MARK	DATE	DESCRIPTIONS	BY	CH'D	CCO#
		REVISIONS			
2	01/31/07	WEST DEVIATION SADDLE GEOMETRY	AS	JD	15
1	07/21/06	W2 CAP BEAM ISD	JD	NV	23

SAN FRANCISCO OAKLAND BAY BRIDGE
EAST SPAN SEISMIC SAFETY PROJECT
SELF-ANCHORED SUSPENSION BRIDGE
(SUPERSTRUCTURE & TOWER)

W2 CAP BEAM DIMENSION DETAILS NO.6

FILE => I:\bb\04-0120I\sas\contract plans and cco\cco\in progress\cco#15\decap05.dgn

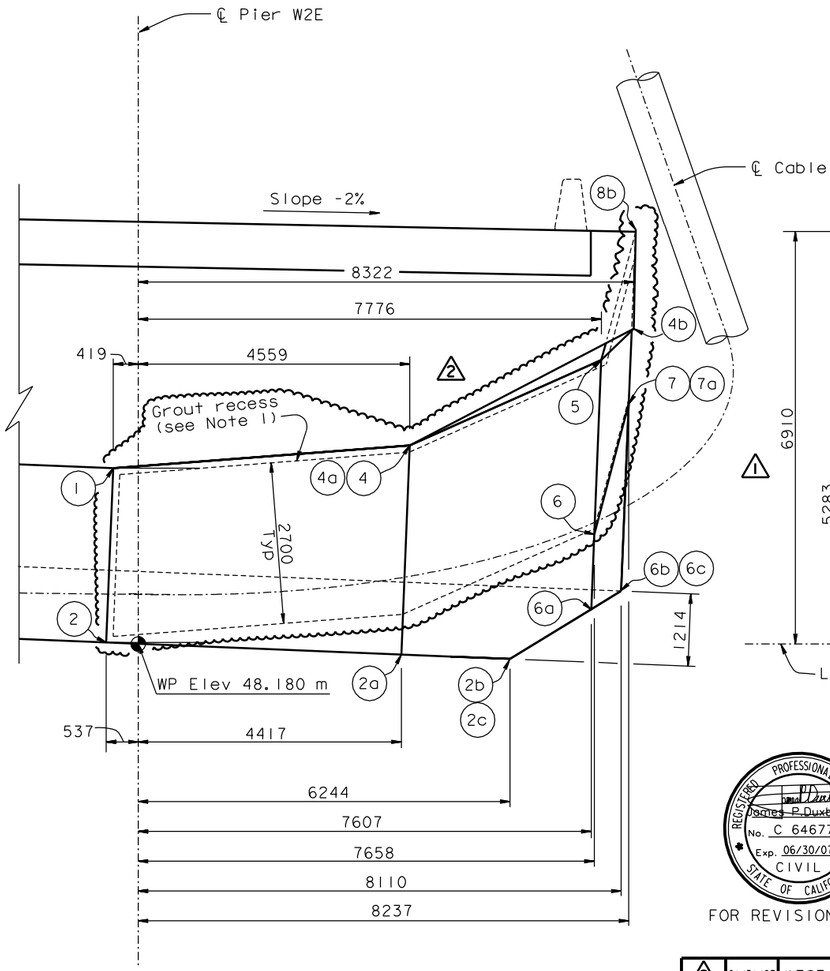
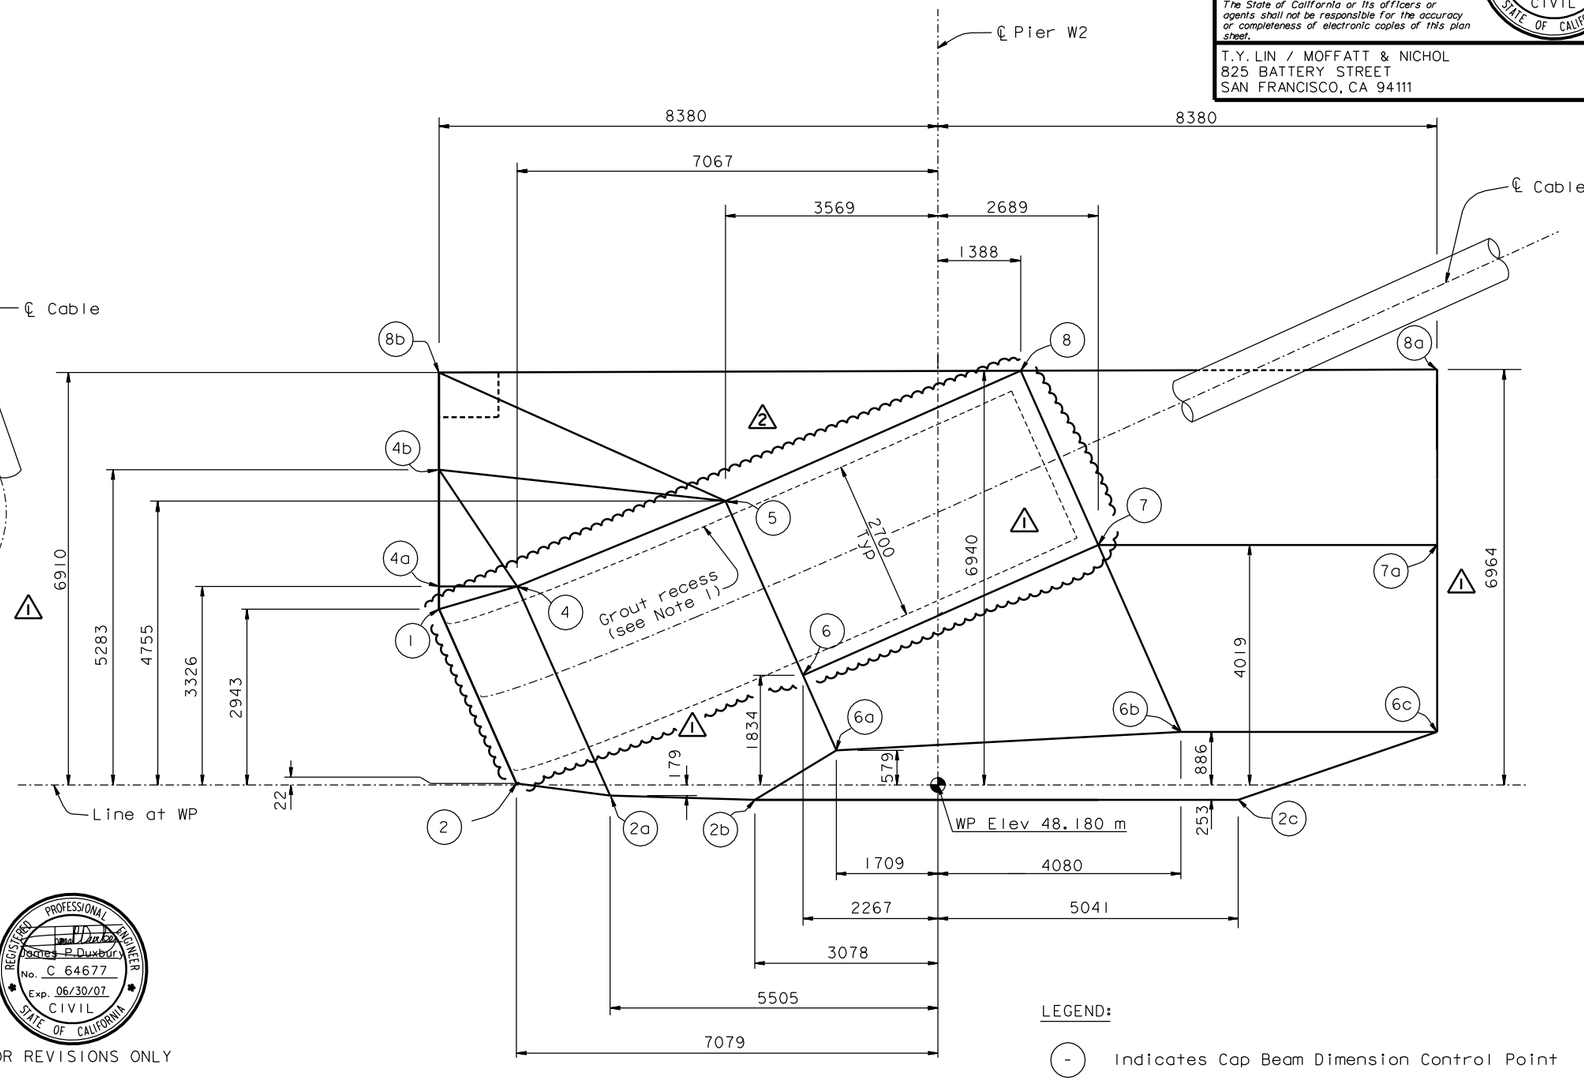
2 1. West deviation saddle grout recess (depth = 50 mm) shall be parallel to concrete faces of cap beam. For details see "West Deviation Saddle Details No.1" and "West Deviation Saddle Details No.2" sheets.

W2 CAP BEAM DIMENSION DETAILS NO. 8

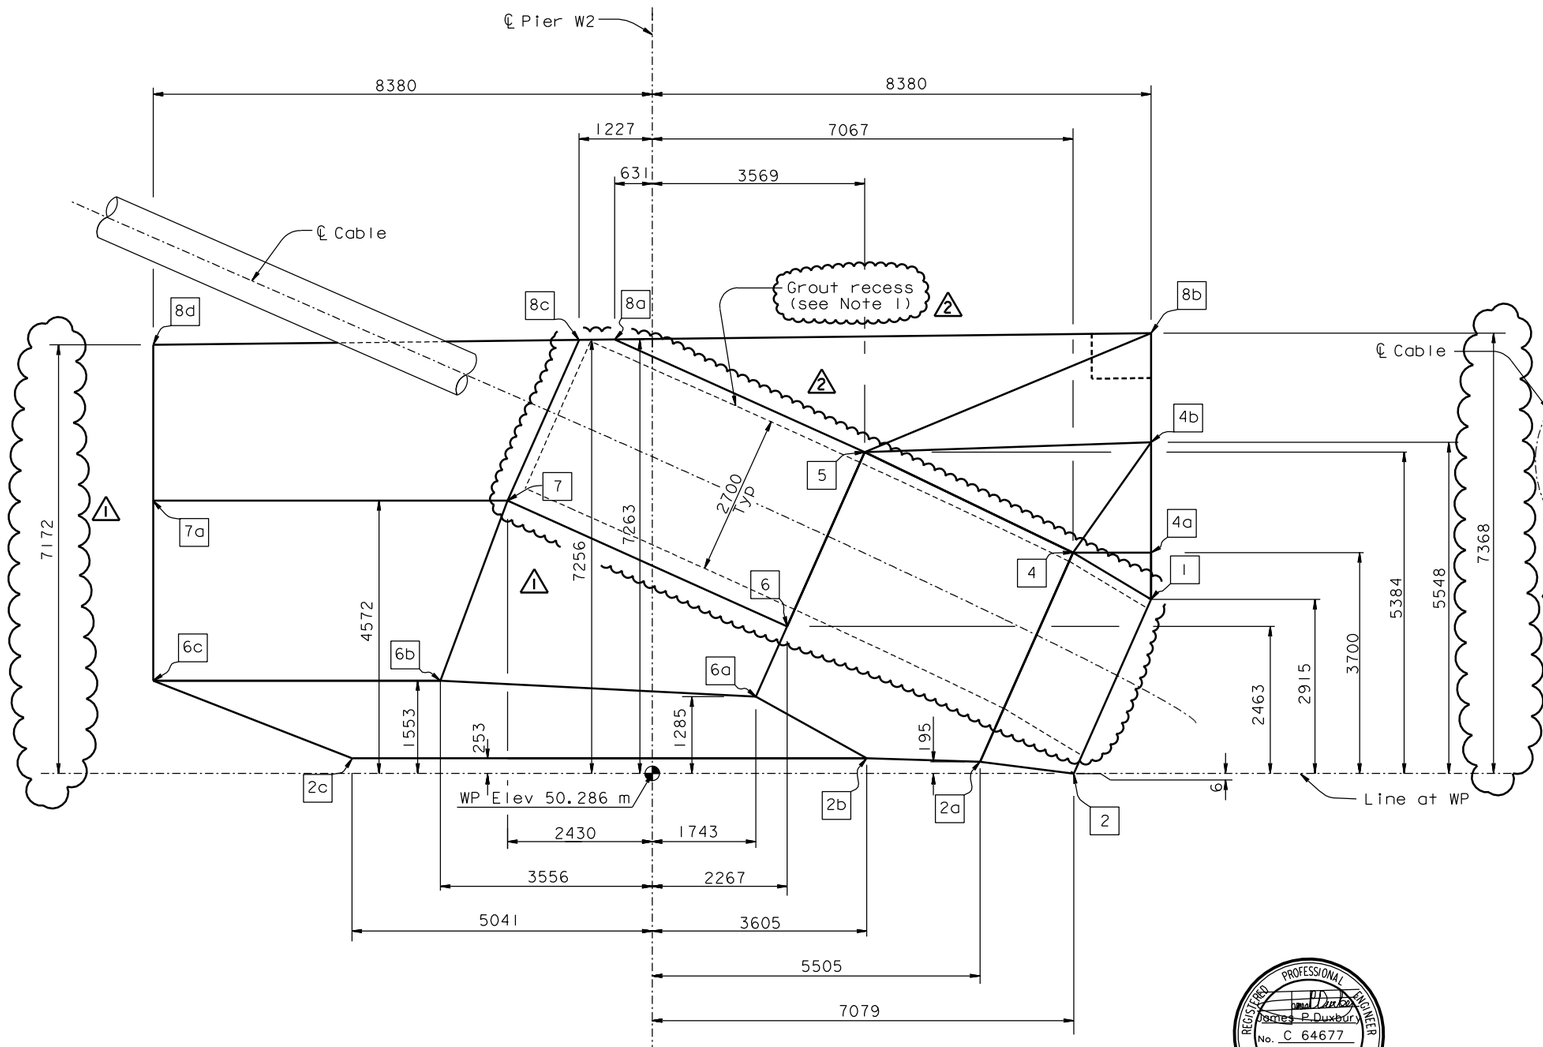
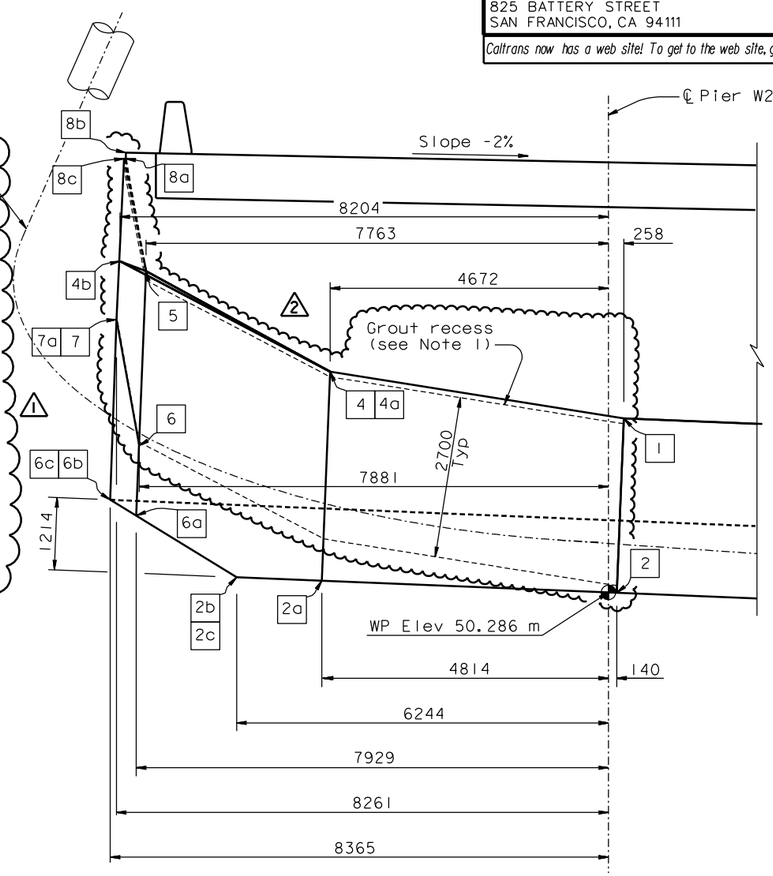
2. West deviation saddle grout recess (depth = 50 mm) shall be parallel to concrete faces of cap beam. For details see "West Deviation Saddle Details No.1" and "West Deviation Saddle Details No.2" sheets.

MARK	DATE	DESCRIPTIONS	BY	CH'D	CCO#
		REVISIONS			
2	01/31/07	WEST DEVIATION SADDLE GEOMETRY	JD	NV	15
1	07/21/06	W2 CAP BEAM ISD	JD	NV	23

W2 CAP BEAM POST-TENSIONING DETAILS NO. 10

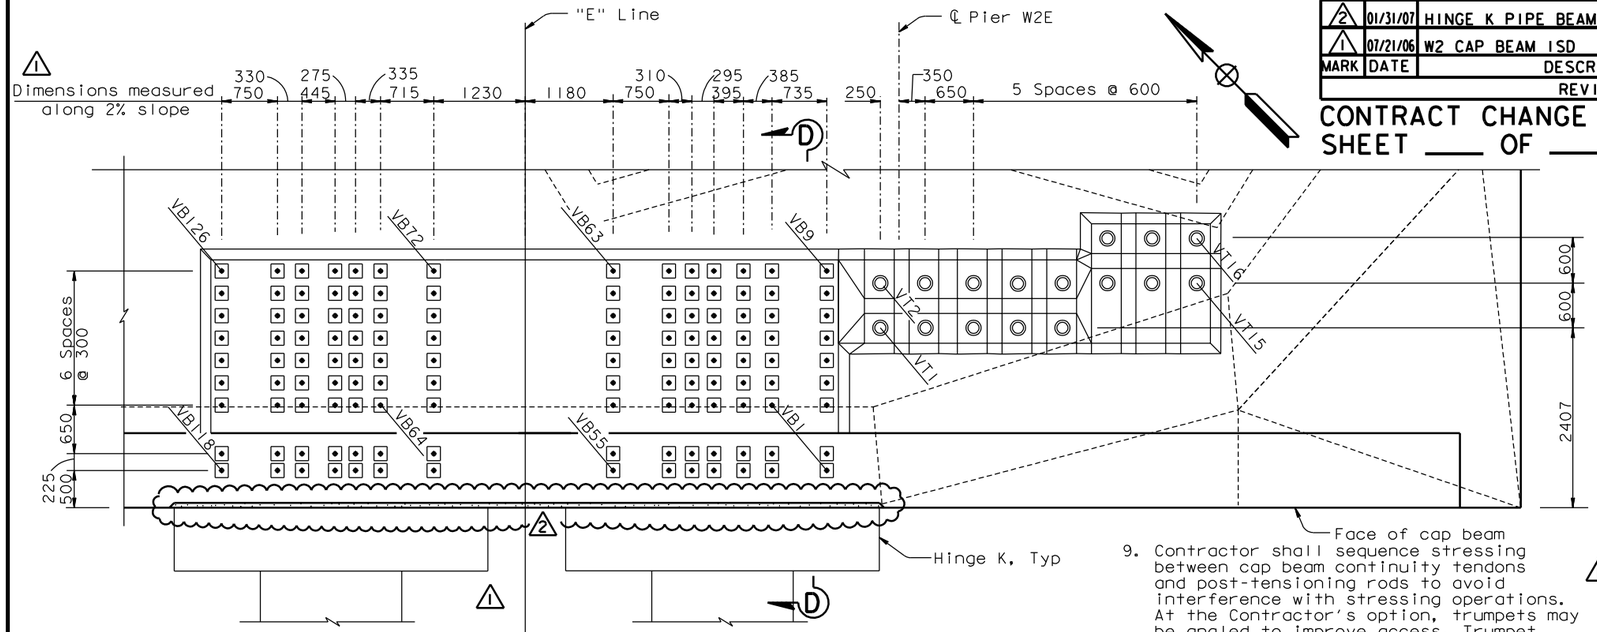
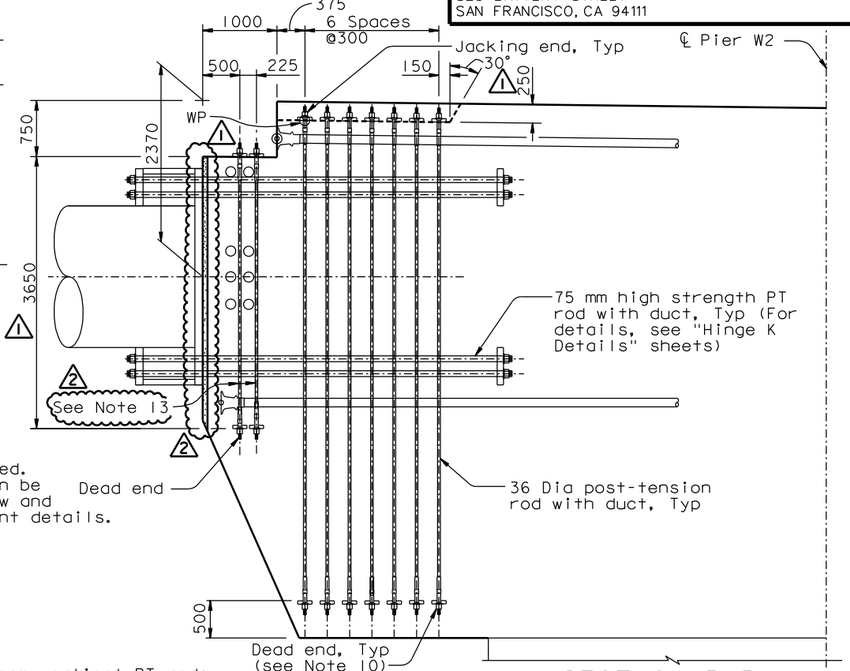
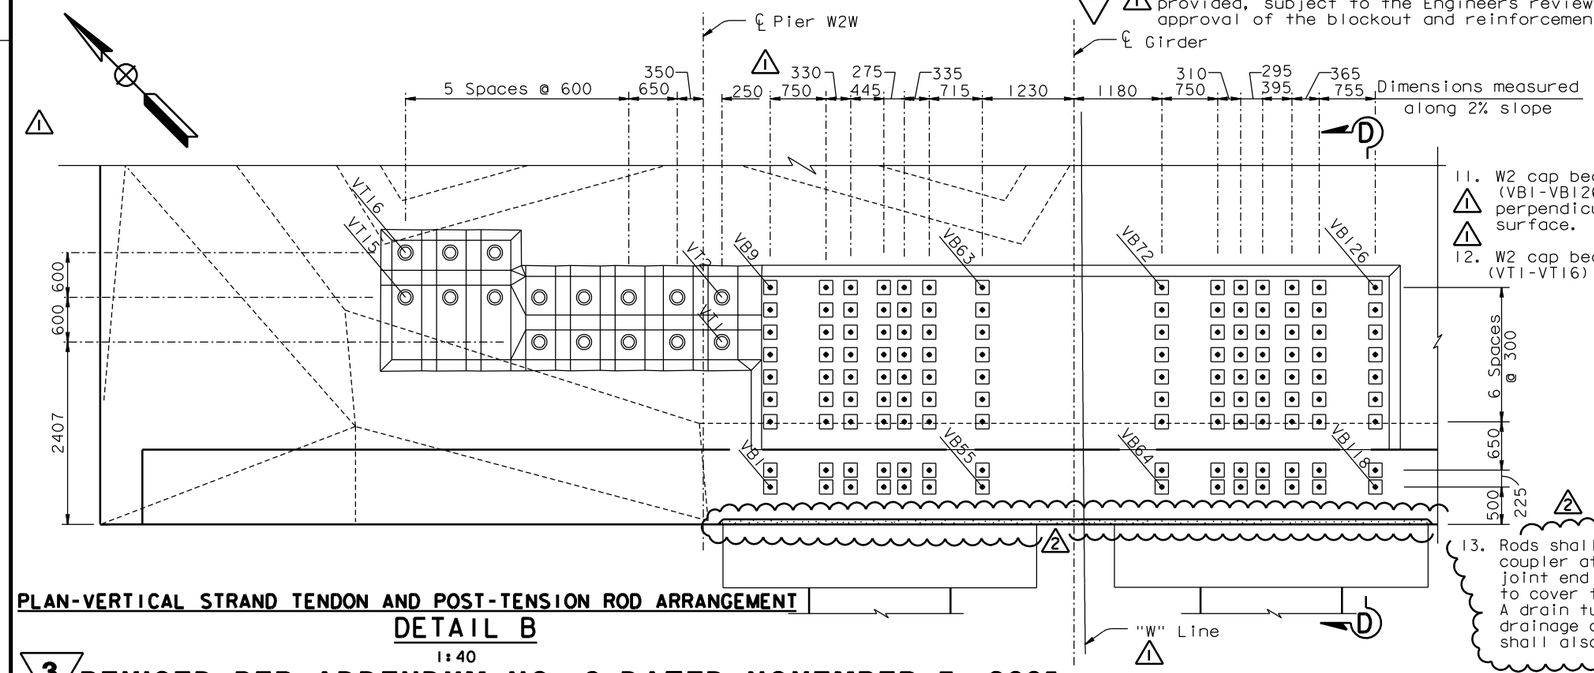
3 / 1 10. Blockouts at the dead end are not required. At the Contractor's option, blockouts can be provided, subject to the Engineers review and approval of the blockout and reinforcement details.

3 REVISED PER ADDENDUM NO. 3 DATED NOVEMBER 7, 2005

W2 CAP BEAM REINFORCEMENT DETAILS NO. 49

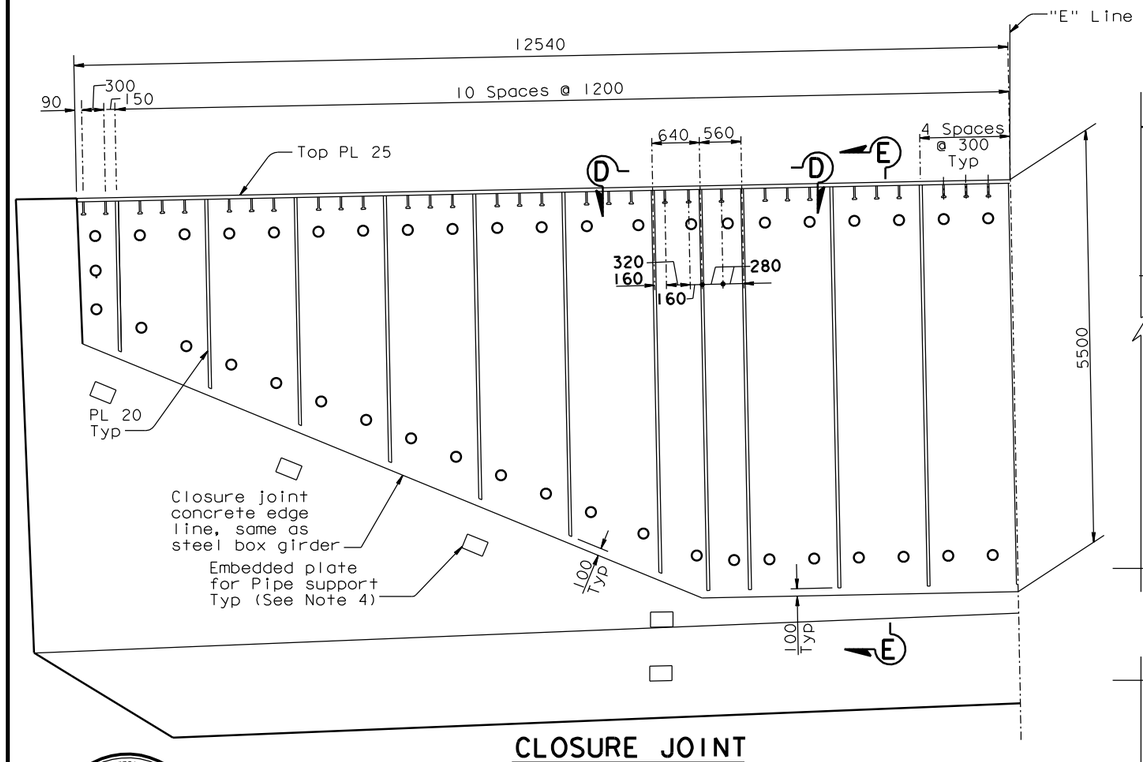
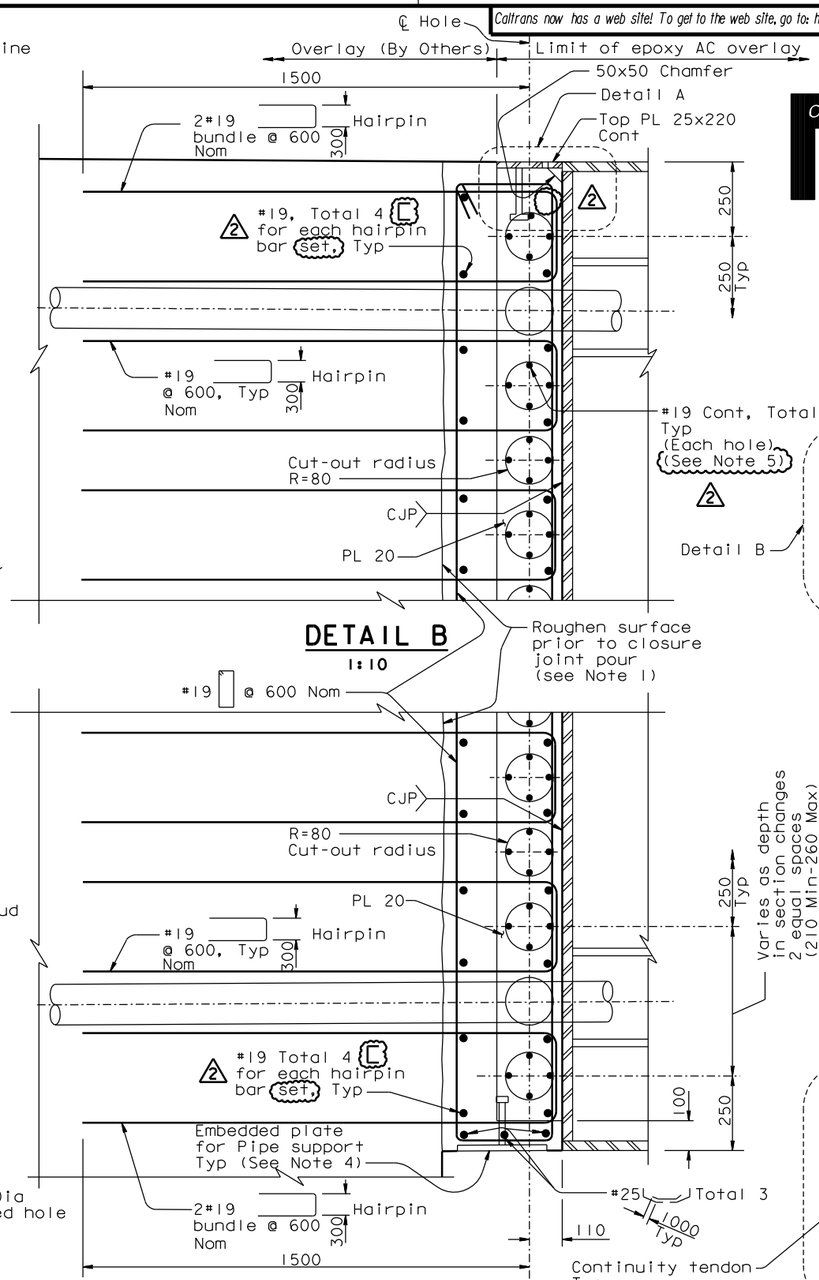
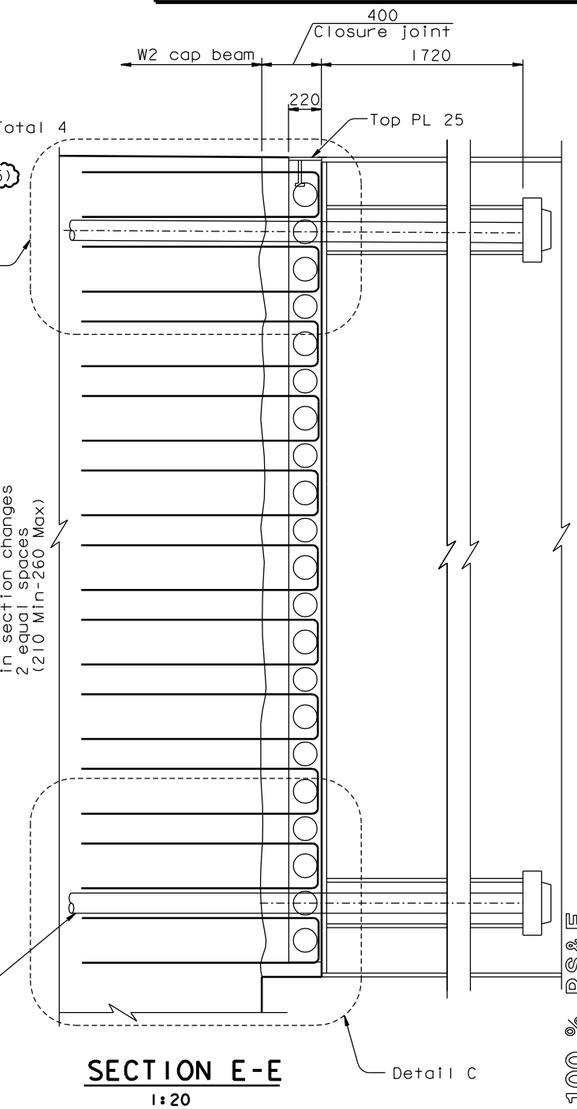
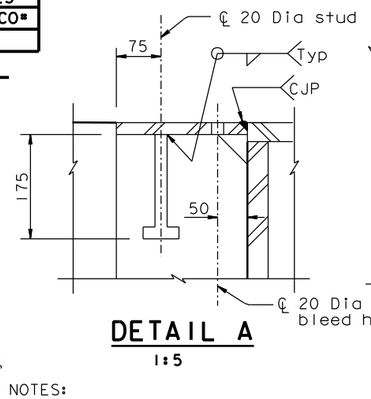
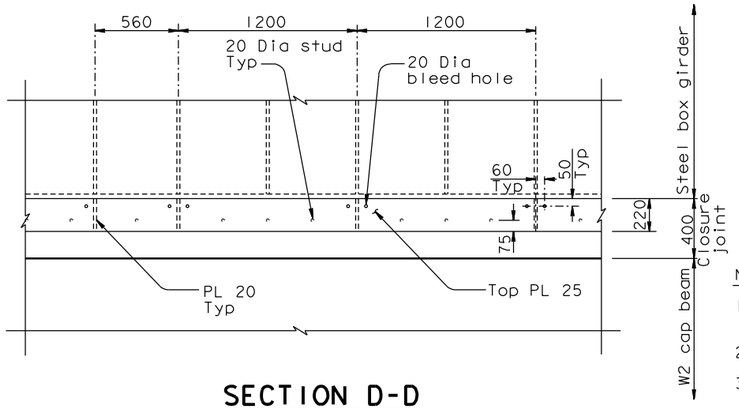
MARK	DATE	DESCRIPTIONS	BY	CH'D	CCO#
		REVISIONS			
2	01/31/07	WEST DEVIATION SADDLE GEOMETRY	JD	AS	15
1	07/21/06	GENERAL REVISIONS	JD	AS	23
